MHTN
ARCHITECTS

Addendum No. 02

Project Name: **SJSD Albert R. Lyman Middle School**

Addendum No. 02 to the Construction Contract for the above-referenced project:

SHEET NAME
ENLARGED ROOF FRAMING PLANS

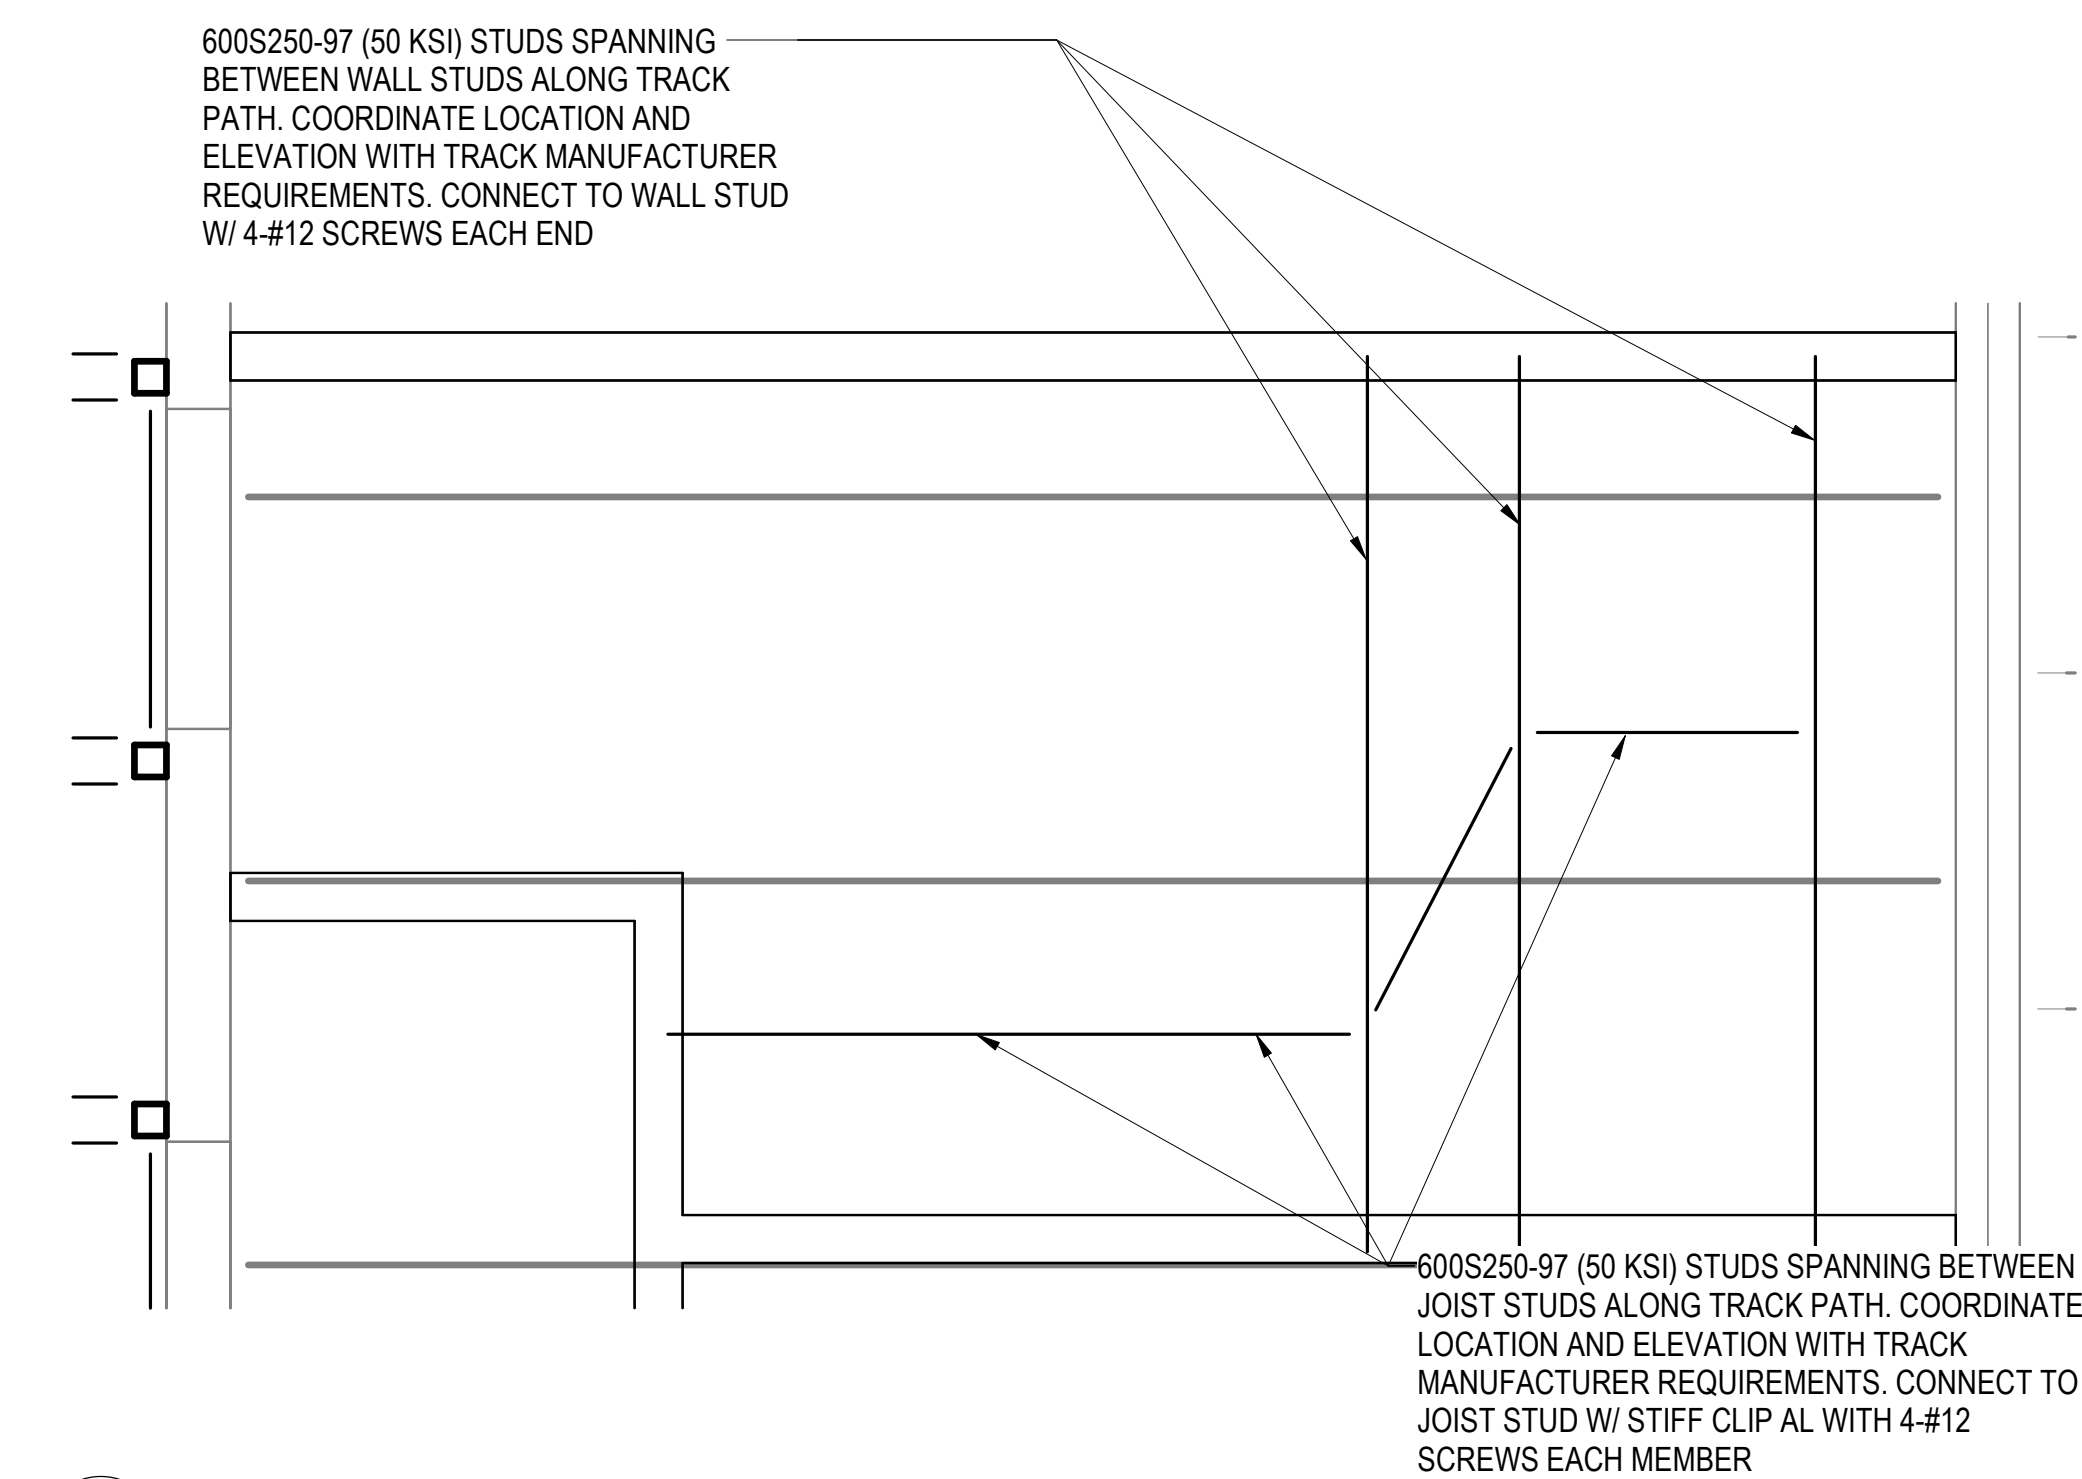
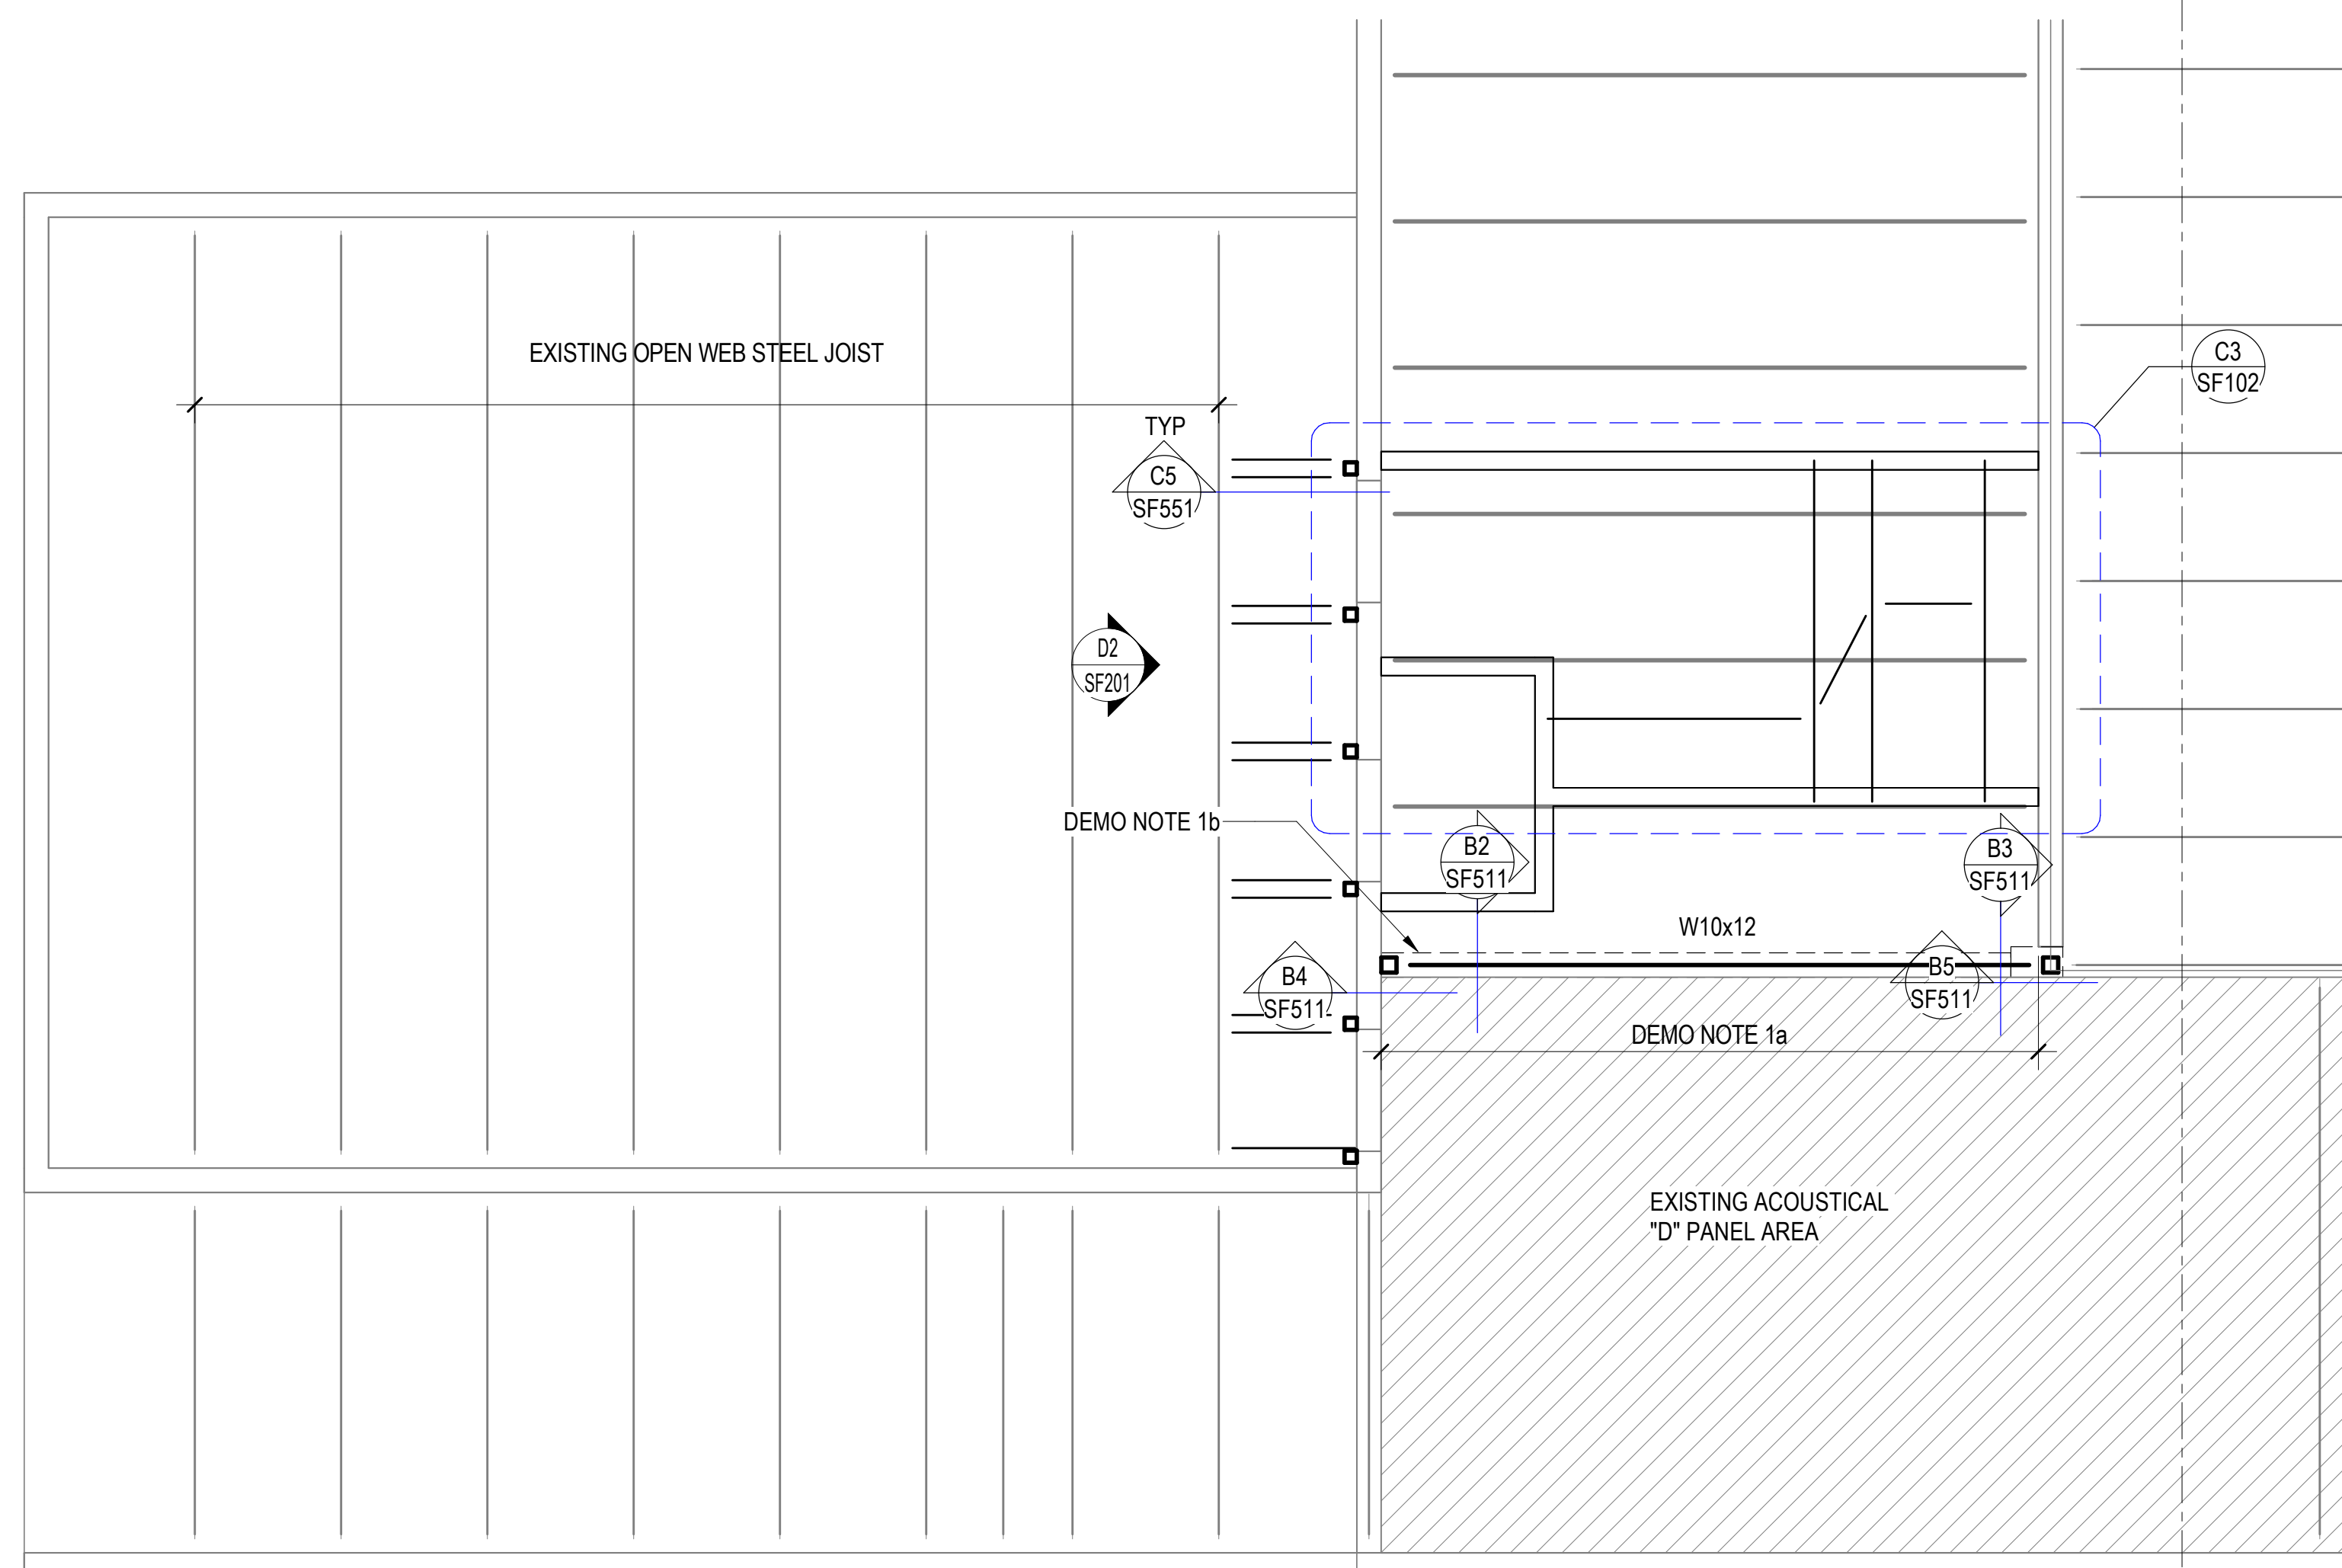
S2.3 Sheet SF102 – Enlarged Roof Framing Plans:
